## Addendum

2

190317.000 | IFB 20-24 HVAC REPLACEMENTS FOR CENTRAL CAMPUS

**INVITATION FOR BID**  
**PROJECT NO. IFB 20-24**  
**HVAC REPLACEMENTS FOR CENTRAL CAMPUS**  
**ENGINEER'S ADDENDUM NO. 2**  
**QUESTIONS AND ANSWERS No. 1**

**M203**

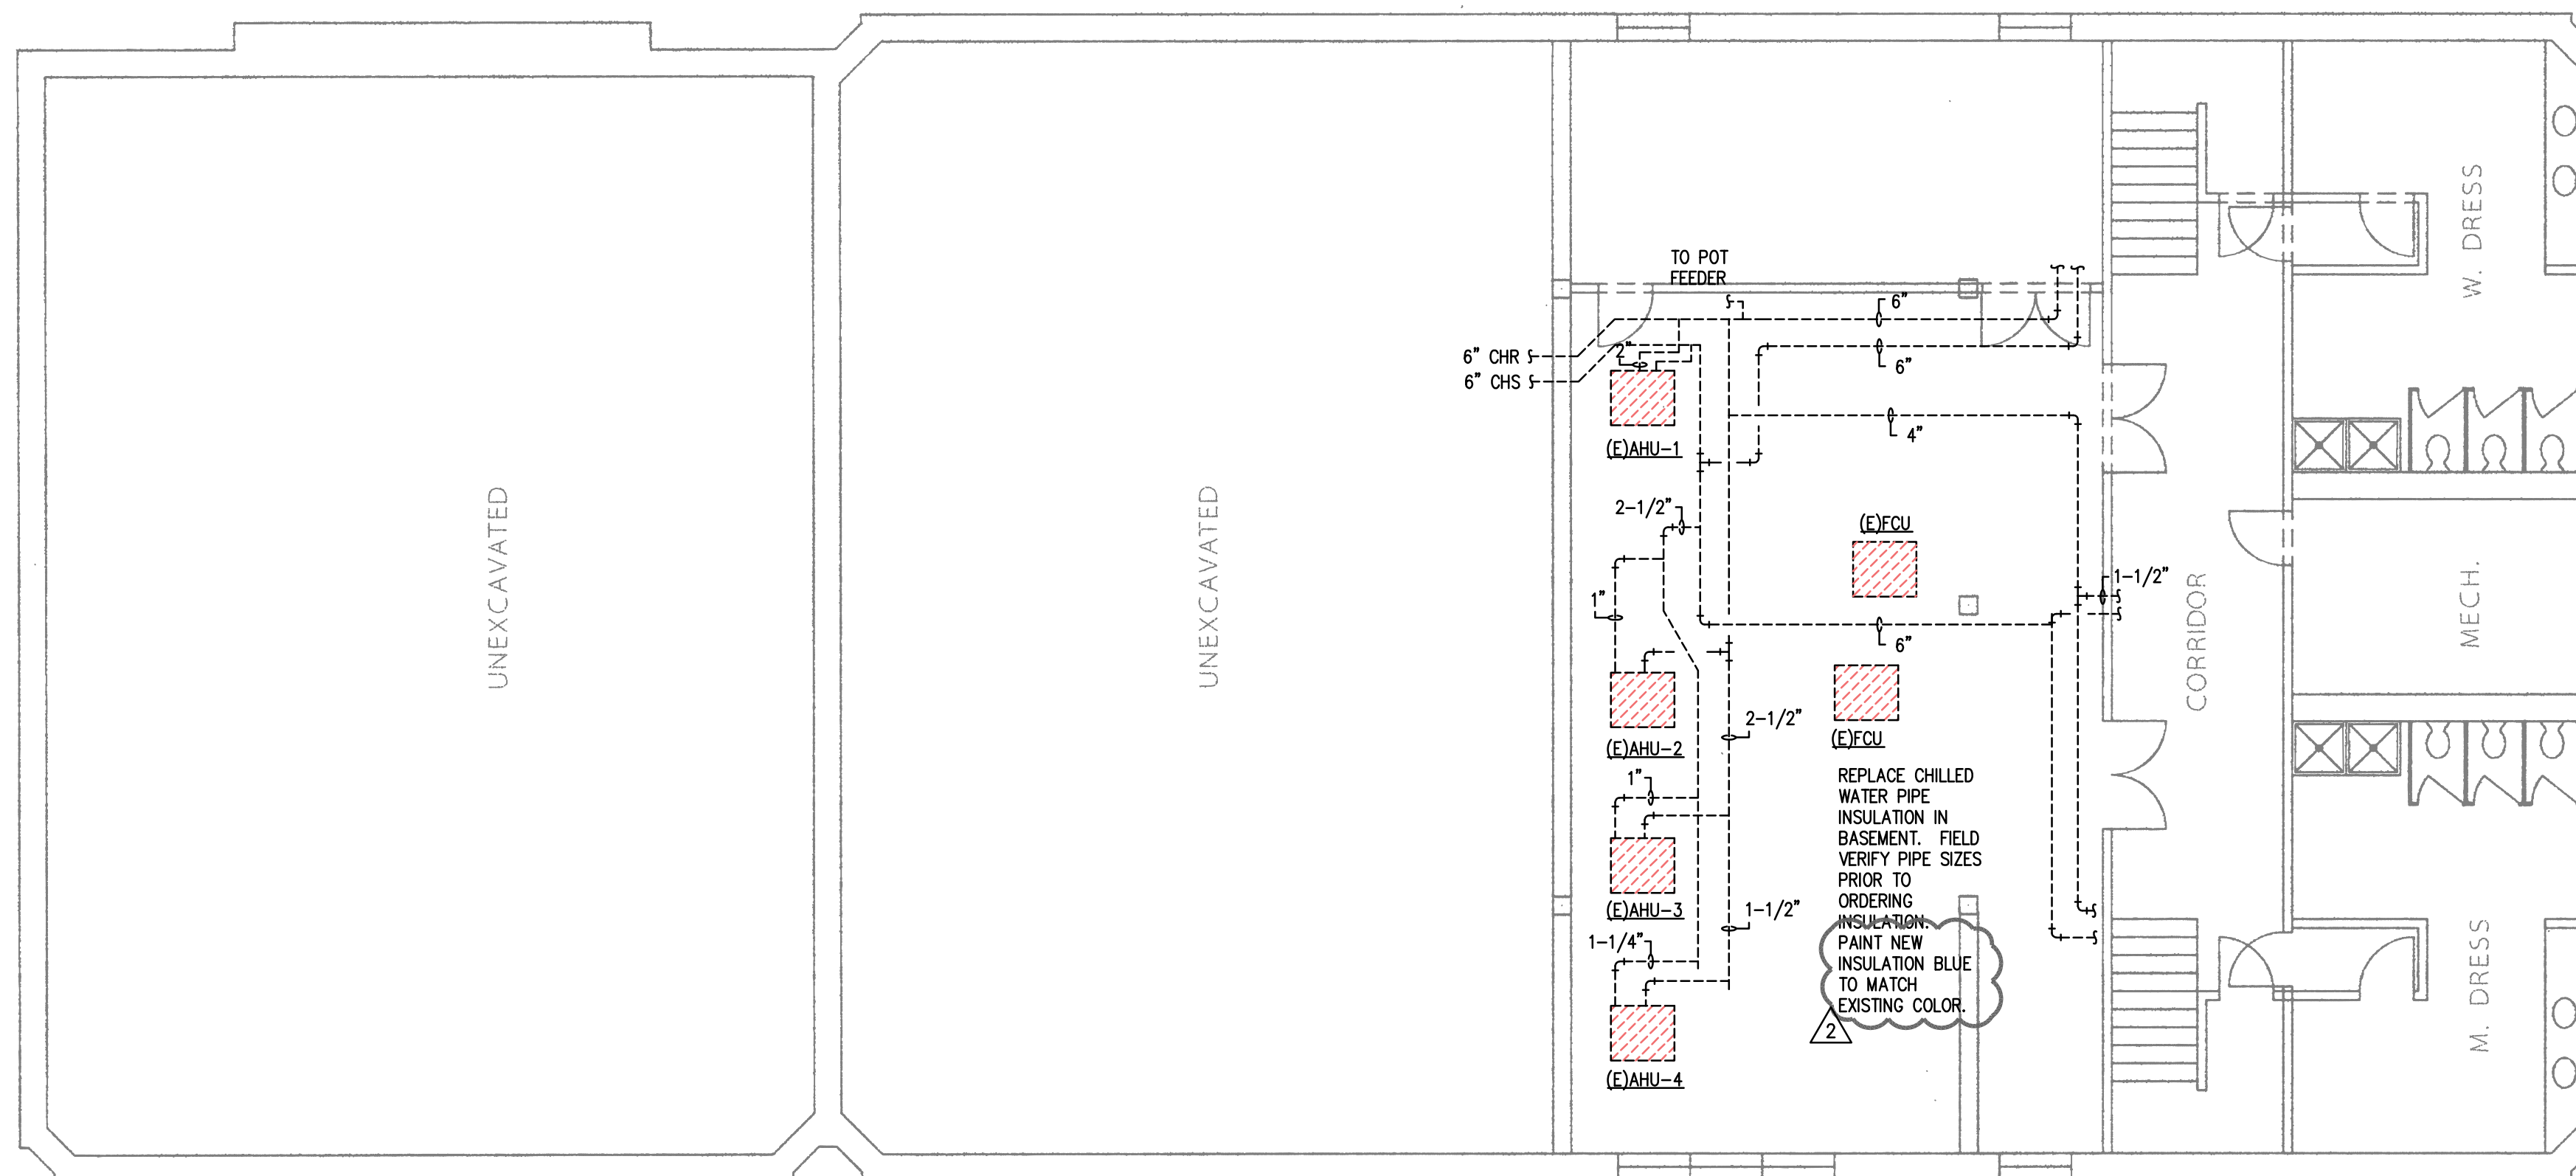
**Item 06** Sheet M203 – Basement Mechanical Plan - Theater

A. Added to notes for chilled water to paint pipe insulation.

Q5. Is the replaced pipe insulation in the Theater Basement get painted as the existing?

**Response: Yes**
